PROJECT MEMORANDUM

Project: Plan Change Application RM220139, J & T Quigley Ltd **Memo:** 1/R2 **Page:** 1 of 6

Topic: Response for a Request for Further Information – Landscape and Visual Effects

Figure 17 View Location Map

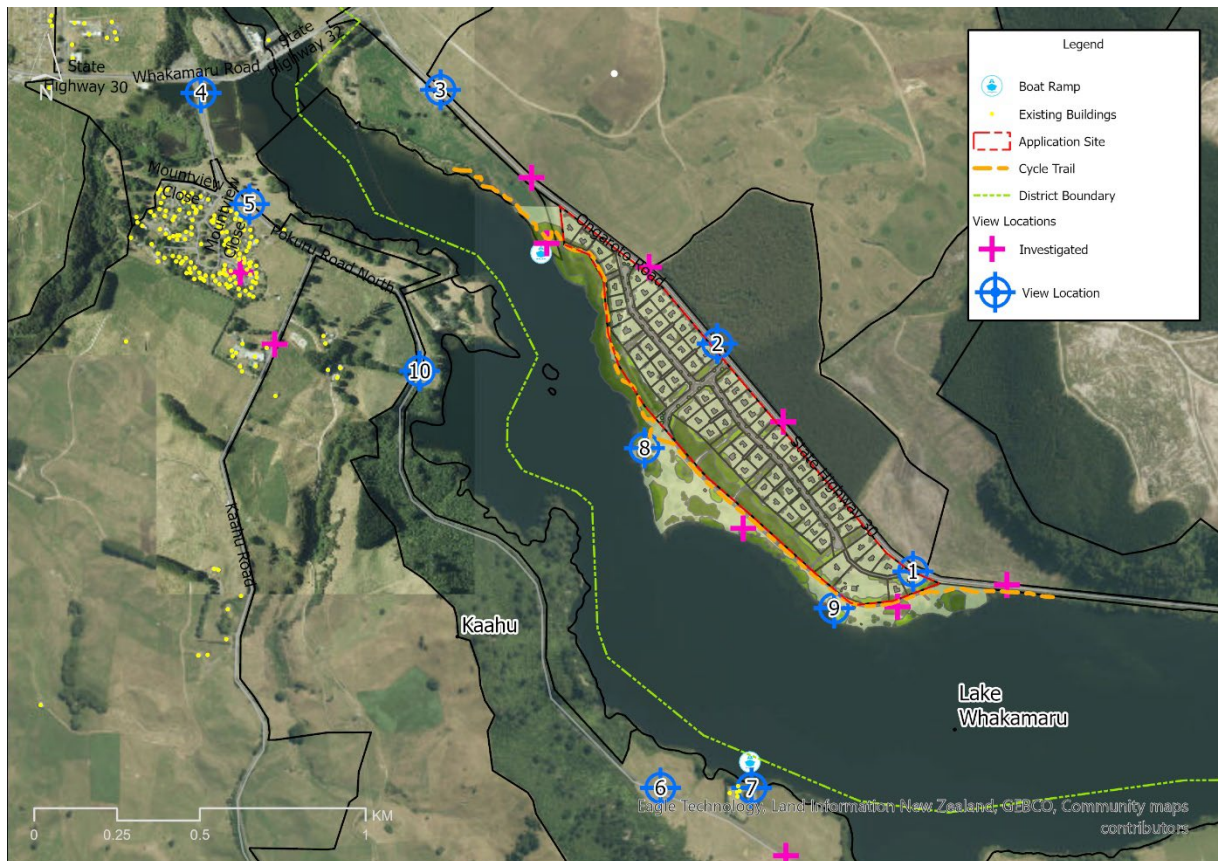
- i) *Further information should be provided on chosen view locations that are outlined within LVA to be representative for other viewing locations. For example for views toward the site from the northwest, including at Sandy Bay Reserve.*

- b. The potential view location was like another view location. This is the case for new VL10 and the Sandy Bay Reserve (discussed further below). These are shown as “investigated” in the below figure.

Representative and investigated view locations are identified in Figure 17 of the report, copied below for convenience. A new view location (VL 10 has been assessed).

Analysis of the effects on visual amenity from view locations 4 & 5 is updated as follows to include the effects from other locations to the northwest, including the road above the Sandy Bay Reserve and the views from within the reserve. These view locations have been grouped together as they represent the various (mainly transitory) views for the west, including views from on the dam, the recreational reserve adjacent to the dam, Whakamaru Village, Pokuru Road North and Sandy Bay Reserve.

From VL10, the development within the site will be visible from across the lake from the south and more prominent than from VL4 and VL5 due to proximity. This will transform the character of the site from rural to rural-residential. To mitigate the effects of the higher development density, screening and mitigation planting will be implemented along the southern boundary of the site, along with enhancement planting within the lakeside reserve. This will help by reducing the visual prominence of the development enabled by the plan change. This approach will facilitate the integration of increased development densities with the broader rural character that surrounds the site. While closer to the application site than VL10, the effect on landscape character and visual amenity from within the Sandy Bay Reserve will be similar. This is because the planting within the proposed vegetation covenant areas (within the site) will be more effective at mitigating the effects of the proposal when viewed across the lake from the lower elevation. The mitigation is further enhanced through an increase in the width of the vegetation covenant areas in response to the s92 request. Further written analysis from other locations within the Sandy Bay Reserve has not been provided because, as outlined above, the nature and magnitude of the effect will be like that described above.
